UNITED STATES PATENT AND TRADEMARK OFFICE

Office Action Summary	Application No. 10/577,118	Applicant(s) CROSSMAN, ARTHUR W.	
	Examiner Manuel A. Mendez	Art Unit 3763

DETAILED ACTION

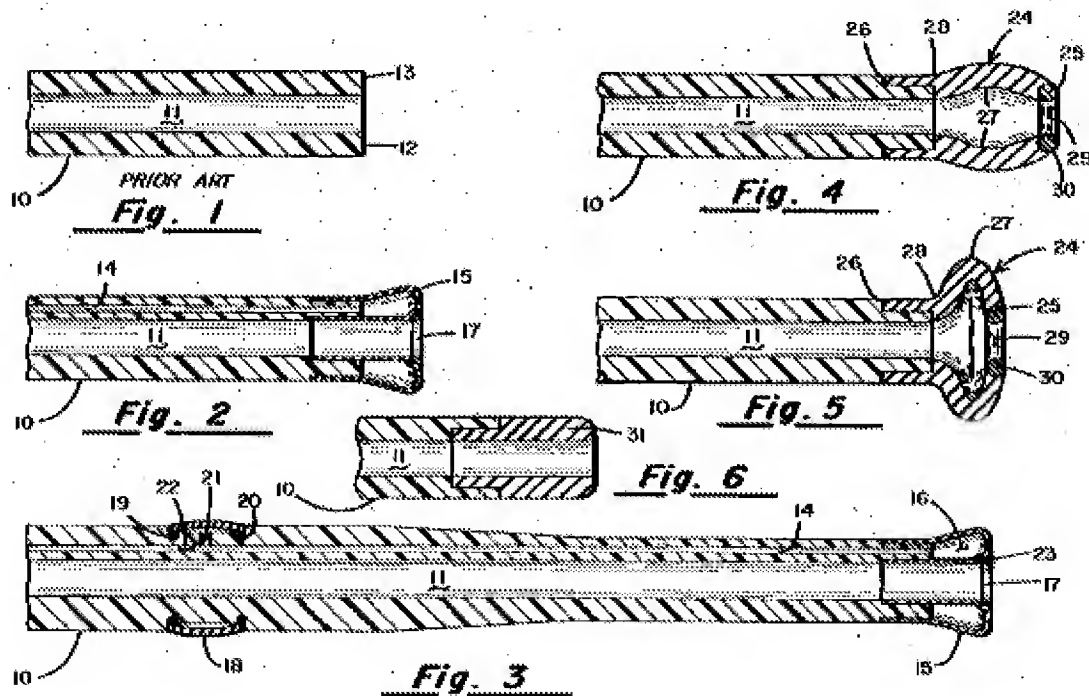
Claim 1, 3, and 4 are rejected under 35 U.S.C. 102(b) as being anticipated by Van Tassel et al. (US 4,531,943; hereafter Van Tassel).

The Van Tassel patent shows in the figures above, a catheter shaft having a proximal portion and a distal portion, and a distal tip disposed on the distal portion, the distal tip having a blunt shape. In relation to claim 3, distal tip (13) is inflatable. In relation to claim 4, figure 4 shows an olive shape distal tip.

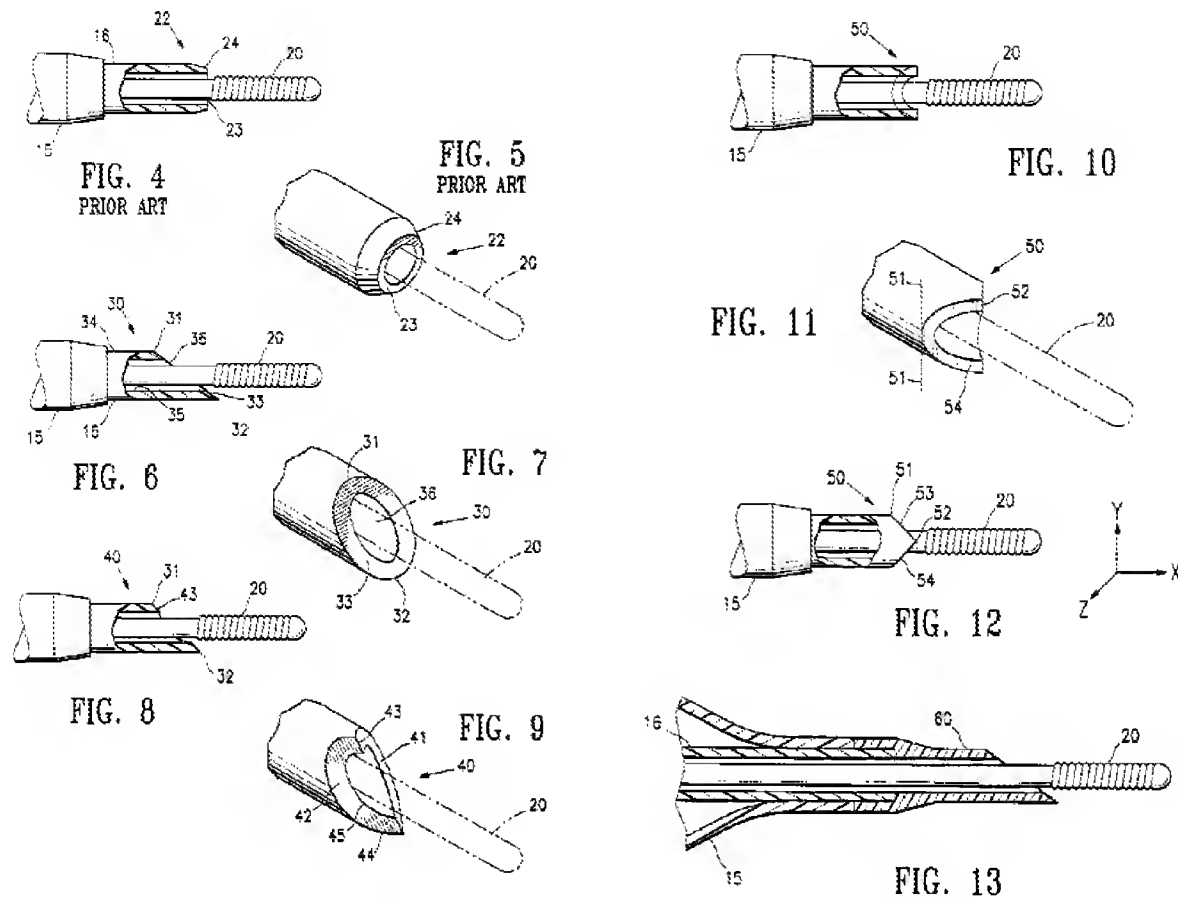
Claims 5-21 are rejected under 35 U.S.C. 103(a) as being unpatentable over **Van Tassel** et al. (US 4,531,943; hereafter Van Tassel) in view of **Lee** (US 6,206,852).

As stated in the previous Section 102 rejection, Van Tassel discloses a set-back extension having an olive shape (claim 14). In the figures above, the Lee patent shows a set-back extension (claim 5), blunt shapes to avoid trauma (claim 6), a tapered set-back extension (claim 7), a set-back extension having a semi-elliptical shape (claims 8, 15, 19, 20), a tip that can be manipulated and that is blunt to avoid trauma (claims 9, 16, 17, 18), a balloon that is inflatable with a pre-formed shape (claims 10, 11, 21), an extension located on the distal end of the distal tip (claim 12), and blunt shapes to mitigate trauma (claim 13).

Based on the above observations, for a person of ordinary skill in the art, modifying the Van Tassel catheter with the enhancements discussed above, would have been considered obvious in the art in view of the proven conventionality of these enhancements, and moreover, because the implementation of these enhancements in the catheter disclosed by Van Tassel would have reduce trauma in patients during surgical procedures.
